**ZONING AMENDMENT &
SUBDIVISION STAFF REPORT****Date: April 2, 2015****APPLICANT NAME**

Pender Ridge Subdivision

Rezoning from R-1, Single-Family Residential District, R-2, Two-Family Residential District, and B-2, Neighborhood Business District, to B-5, Office-Distribution District, to allow a heavy equipment storage facility and Subdivision approval to create four (4) legal lots of record.

SITE PLAN

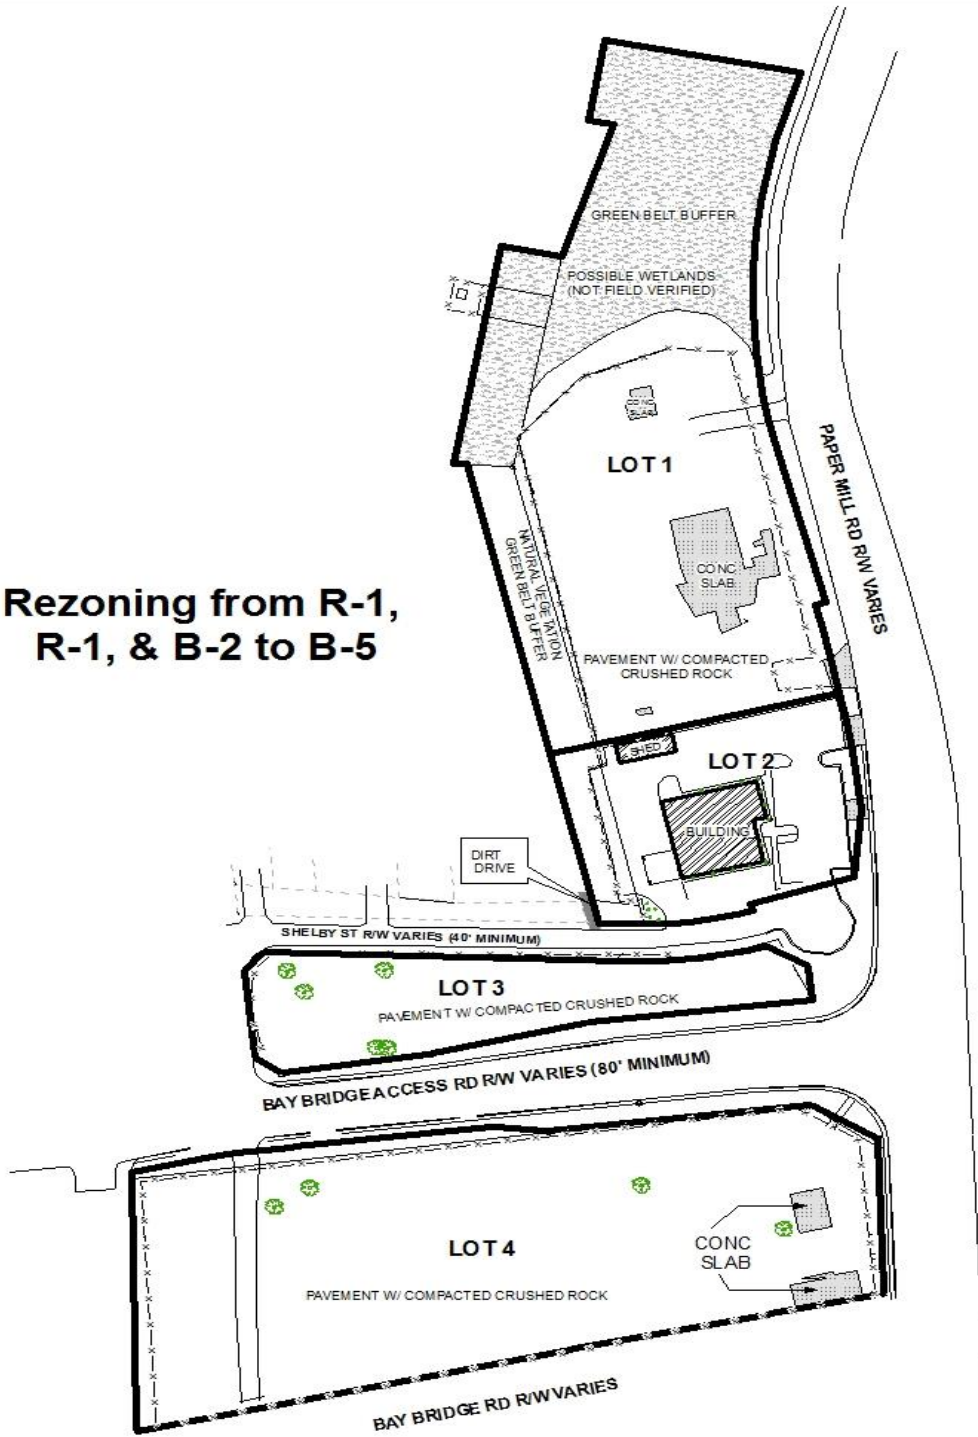
It should be pointed out that the site plan depicts crushed rock surfacing on the proposed Lots 1, 3, and 4. It appears that gravel surfacing was added to Lot 1 recently, without any permits or approvals, based upon a recent site visit initiated by a citizen complaint. Recent photos also show a new chain-link fence with barbed wire that also appears to have been installed without permits. Gravel surfacing is only allowed by right in I-1 and I-2 districts, and therefore, a variance from the Board of Zoning Adjustment will be required to allow the use of gravel for parking: otherwise, a paved parking surface will be required if the variance is not approved. A building permit for new fencing and approval by the Director of the Urban Development Department will be required for the barbed wire fencing.

The site plan depicts several large oak trees. Although dimensions are not depicted, the removal of any Live Oak tree greater than 24" will require a Tree Removal Permit.

No proposed sidewalks are illustrated on the site plan. Any future commercial use of the proposed lots will necessitate the installation of a sidewalk, or an application for a waiver may be submitted.

As mentioned, the site has frontage along multiple streets: Bay Bridge and Paper Mill Roads, Paper Mill Road Extension, Edwards and Shelby Streets, Tin Top Aly, and Peace and Wiley Lanes. The right-of-way widths are depicted as variable; however, the minimum right-of-way should be depicted, per Section IV.A.2.d. of the Subdivision Regulations, and so that Staff can determine if the existing right-of-way widths are sufficient. It should be pointed out that the unopened right-of-way of Wiley Lane is not depicted but should be illustrated on the revised plat.

The 25' minimum building setback line is not illustrated on the plat and should be depicted along all road frontages and street stubs on the Final Plat, if approved.

It should be pointed out that there is an underground pipeline that runs through the site which indicates there is an easement not shown on the preliminary plat. As such, if necessary, the Final Plat should be revised to illustrate all easements along with a note stating no permanent structure can be placed or erected within any easement, if approved.

- 1) Revision of the plat to include the entirety of parcel R022208440020031. for proposed Lot 1, or provision of documentation to show that the entirety is included;
- 2) Submittal of labels and postage so that appropriate notification of all property owners can occur, if additional notification is required due to the inclusion of the entirety of the parcel;
- 3) Revision of the plat to depict the unopened right-of-way of Edwards Lane along the northern boundary of Lot 1;
- 4) Revision of the plat to depict the minimum widths of all public rights-of-way;
- 5) Revision of the plat to depict the 25' minimum building setback line along all road frontages; and
- 6) Revision of the plat to depict all easements, along with a note stating no permanent structure can be placed or erected within any easement, if necessary.

- 1) Revision of the site plan to include the entirety of parcel R022208440020031. for proposed Lot 1, or provision of documentation to show that the entirety is included;
